Alterations and Additions to Waverley College - On Site Detention Tank Design Amendment

This letter has been provided as an addendum to Revision 07 of the IWMP and summarises the changes to the proposed onsite stormwater detention (OSD) location that has occurred during the SSDA review process.

WC Bldg 1 - Phase 1
131 Birell St, Waverley
NSW, 2024

60675600-SHT-00-1000-CI-0631

SSDA submission (August 2024)

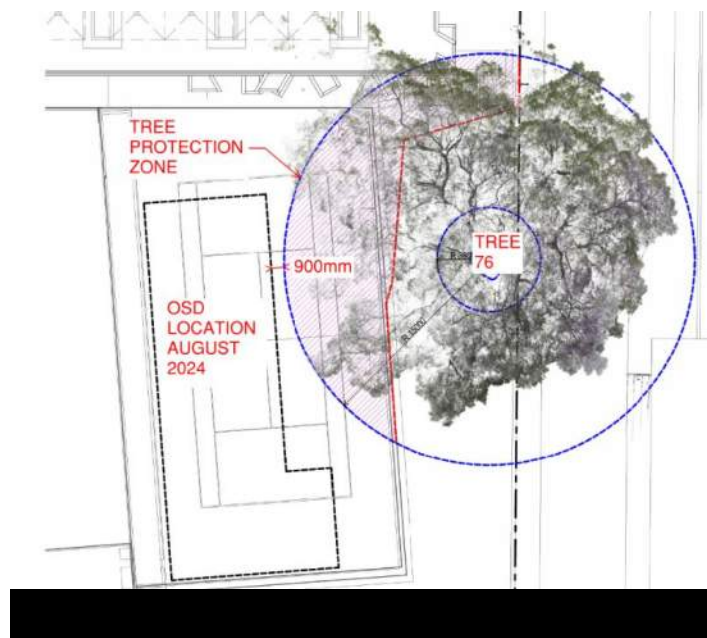
The figure below demonstrates the OSD design at the time of SSDA submission and shows its position relative to tree 76.

Features of the OSD include;

1. OSD is located outside of tree protection zone for Tree 76
2. OSD eastern wall 900mm from edge of tree protection zone of Tree 76
3. Total surface area of OSD is 300m²
4. OSD is proposed as precast segments to minimise disruption during construction

Current design (May 2025)

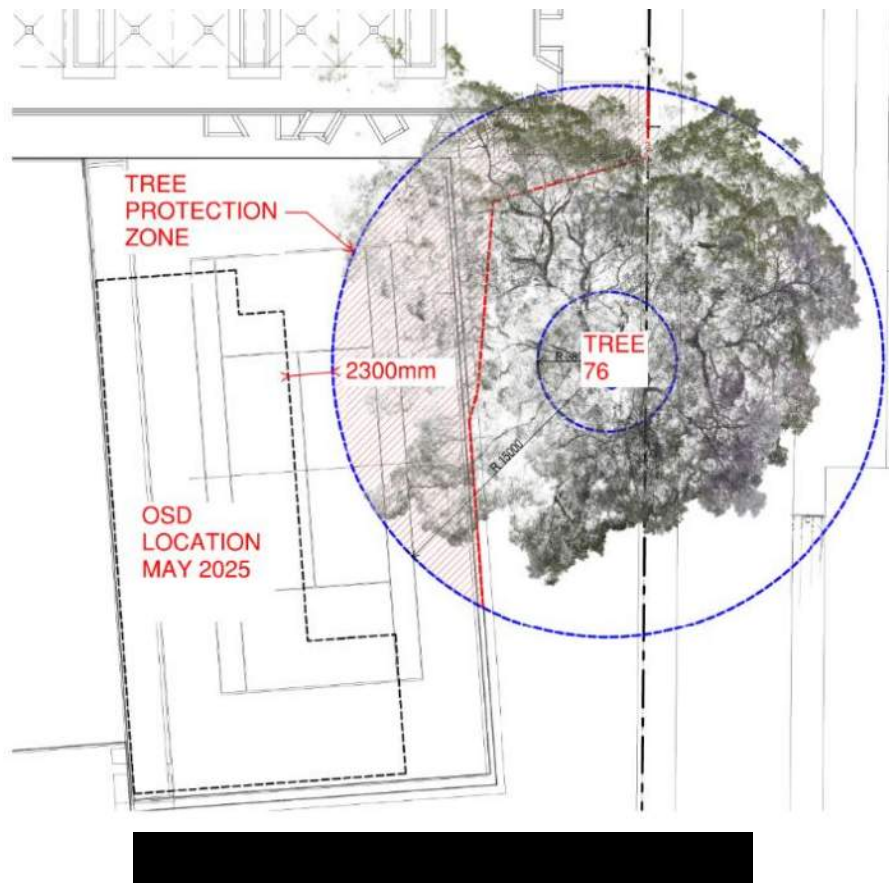
The figure below demonstrates the OSD design at the time of response to submissions and shows its position relative to tree 76.

The key change to design is a shift of the OSD tank 1.4m West further away from the tree protection zone.

Features of the OSD include;

1. OSD is located outside of tree protection zone for Tree 76
2. OSD eastern wall 2300mm from edge of tree protection zone of Tree 76
3. Total surface area of OSD is 310m²
4. OSD is proposed as precast segments to minimise disruption during construction

Figure 3 Comparison of SSDA to May 2025 OSD location

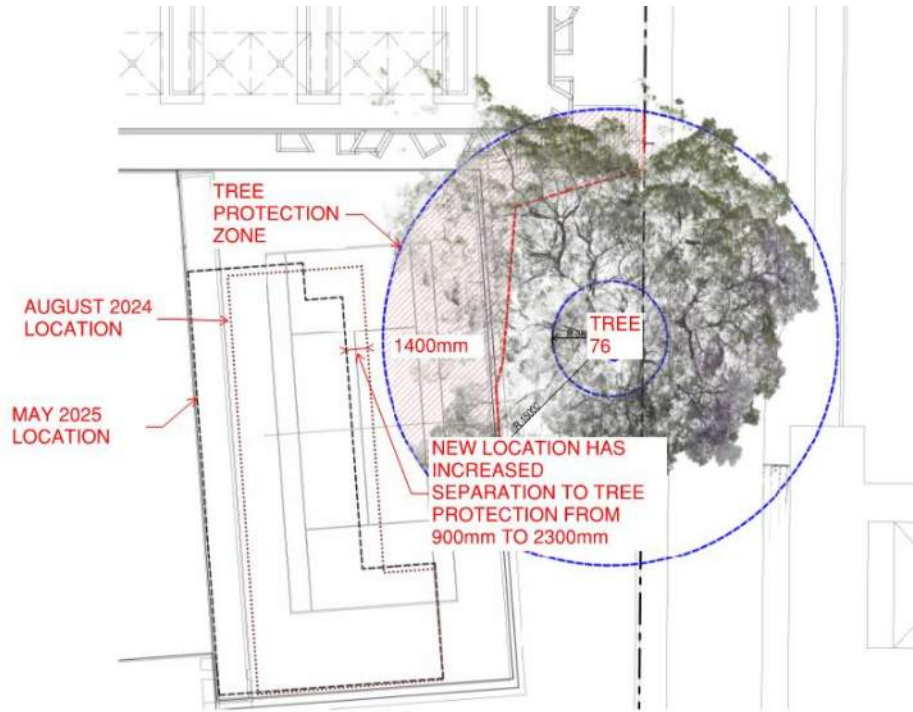
The figure below shows a comparison of the SSDA location (August 2024) and the latest location (May 2025). This figure shows that the OSD has moved an additional 1.4m west further away from the tree protection zone of tree 76.

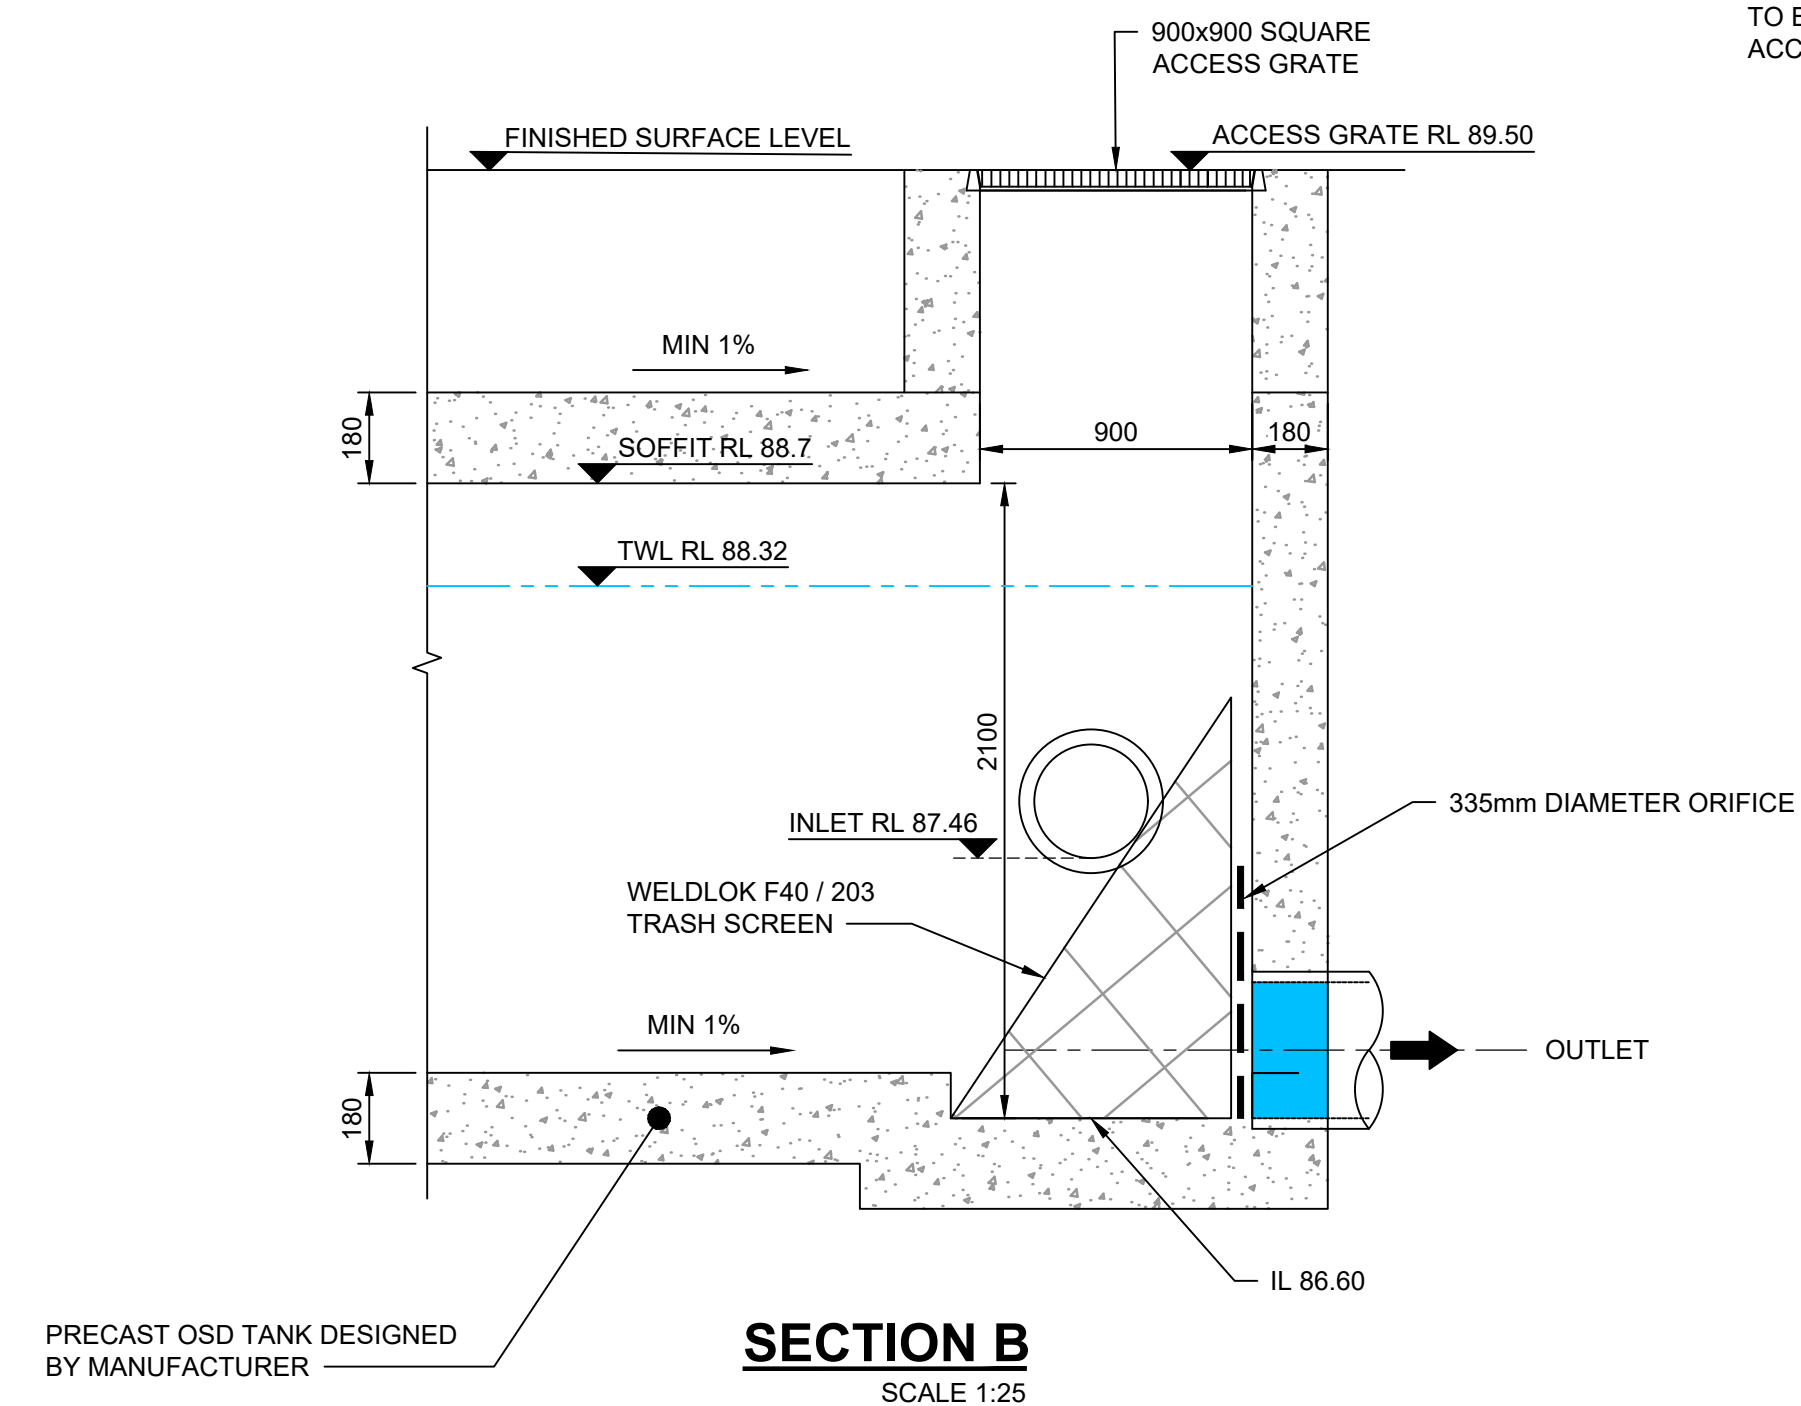
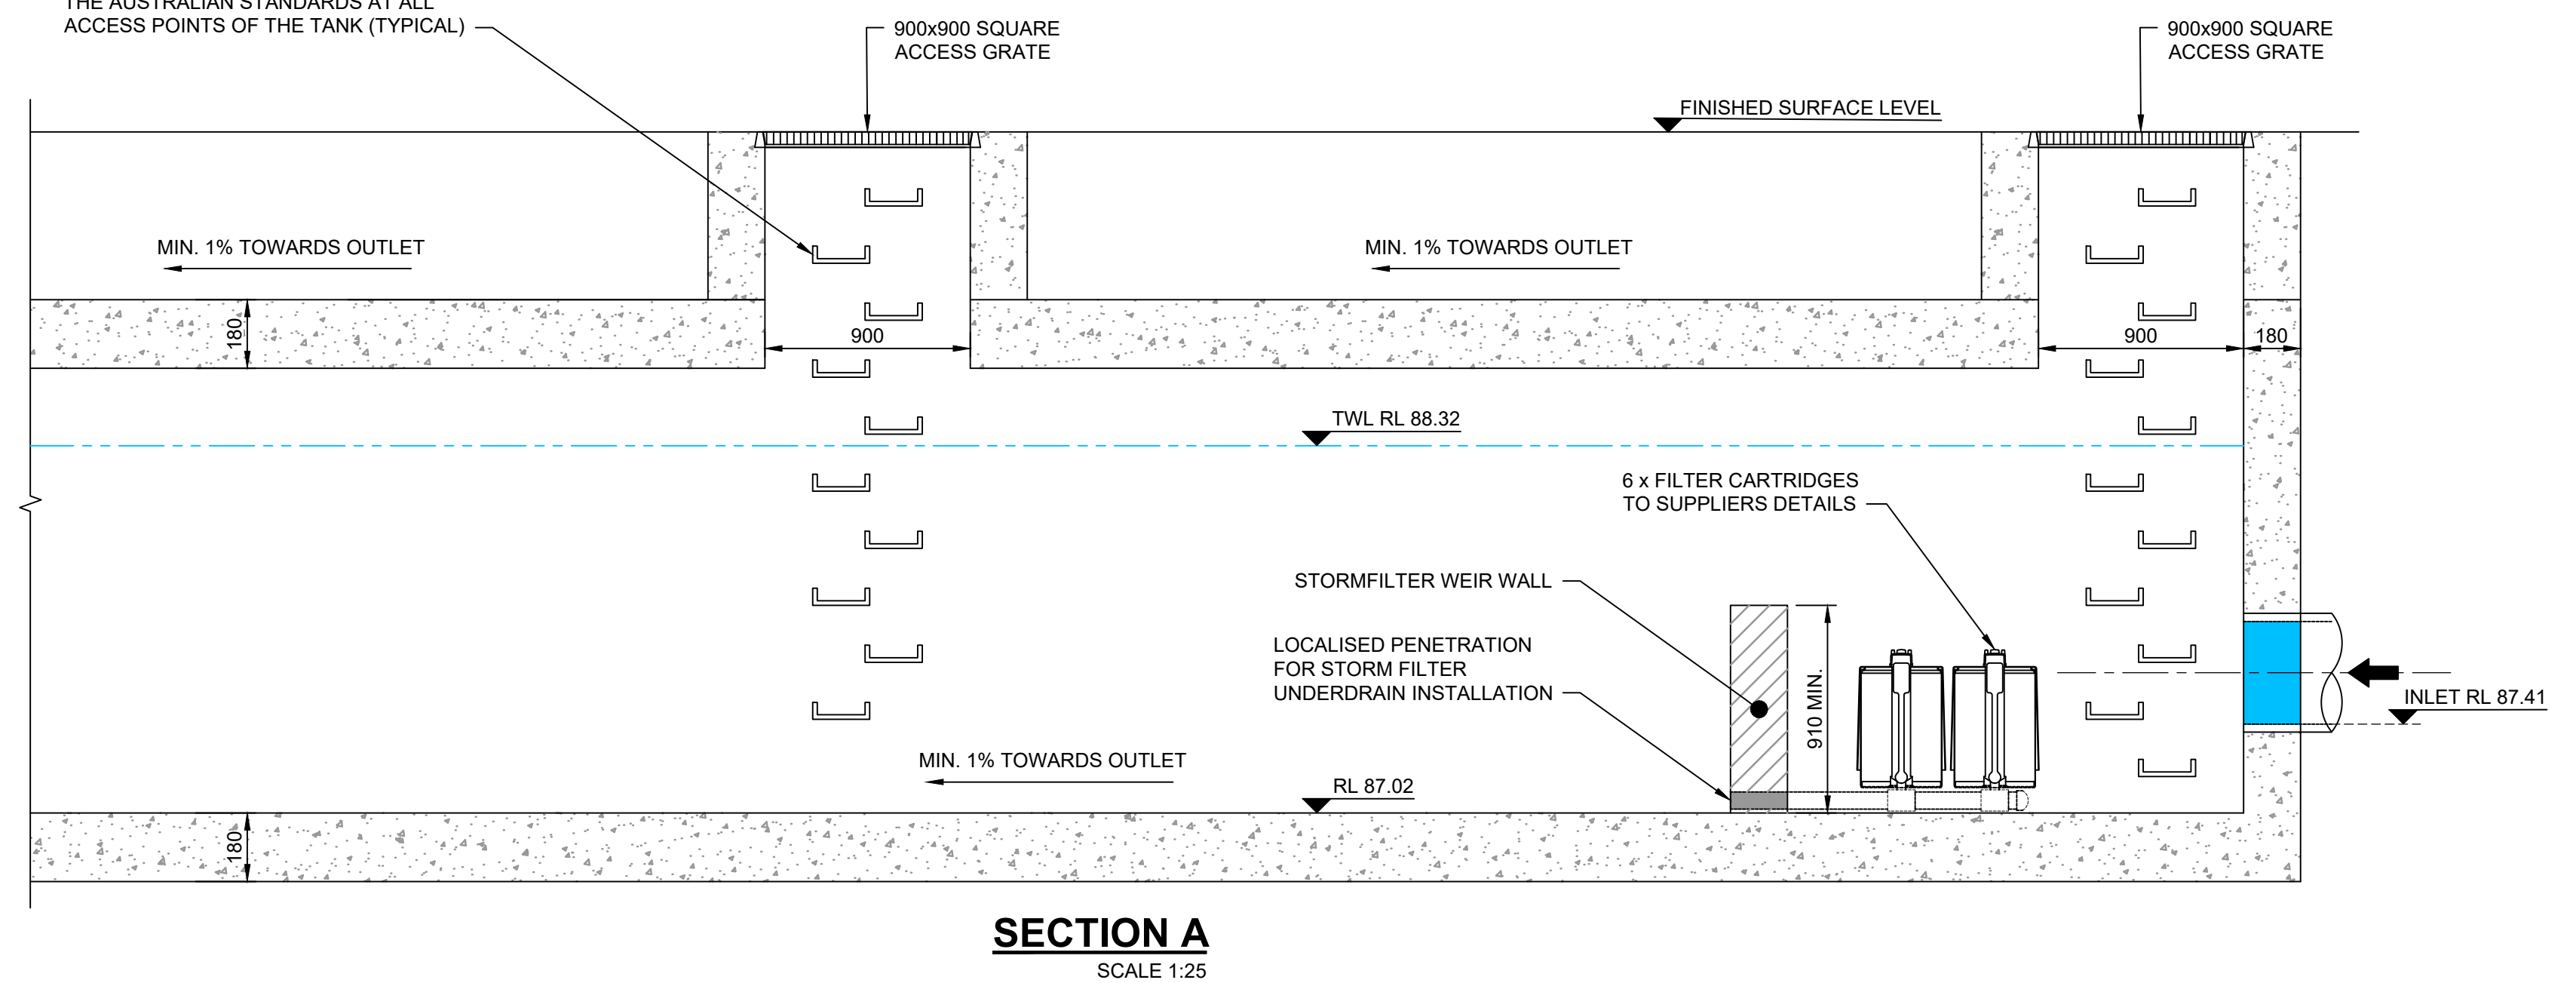
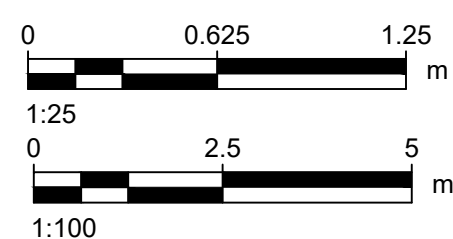
The location change of the project OSD impacts drawing 60675600-SHT-00-1000-CI-0631 (Stormwater Drainage Typical OSD Tank Sections). This drawing summarises the location and design of the project OSD. The latest drawings is attached to this letter.
